LLNL-TR-500095

COMMENTS ON BECHTEL'S "RADIO FREQUENCY INTERFERENCE TEST PROCEDURE FOR INSTRUMENT AND CONTROL SYSTEMS"

R. J. Kane

September 21, 2011

This figure shows the electric field (blue surface) in the vicinity of the HRSG structures where a perfectly conducting (PEC) ground has been used. The use of a PEC and 'real' ground have been compared and there is little difference for the purpose of this review.

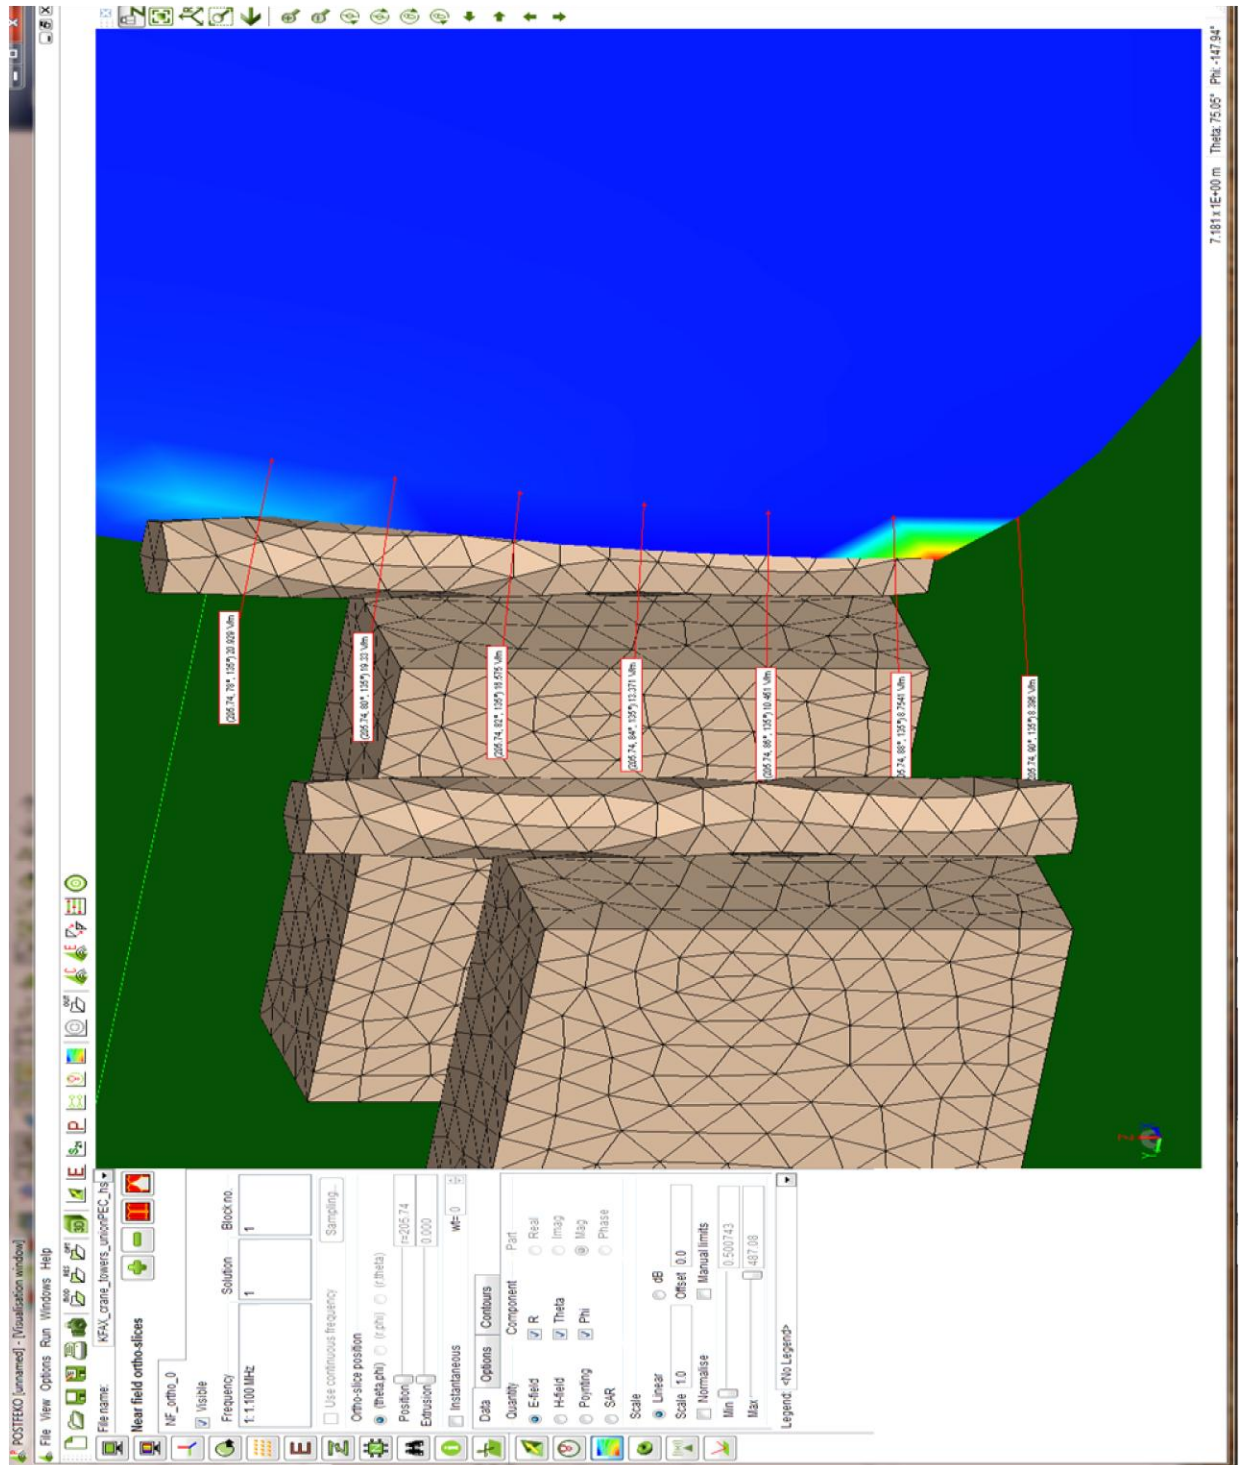
A simple simulation was performed to estimate the fields in the region where the HRSR will be installed. The attached screen-shot shows the E-field reaching values of ~ 20 V/m near the top of the structure and possibly higher immediately adjacent to the simulated structure. These voltages are not a human safety concern but they exceed the IEC and OSHA Standards for RF immunity in instrumentation. The Hatfield and Dawson report referenced a level of 3 V/m and 10 V/m is a value encountered for US medical instrumentation tolerance. The corresponding induced currents are also small; approximately 50 mA. The structural shielding will reduce the levels provided the cabling, conduit and raceways are all well-connected and grounded.
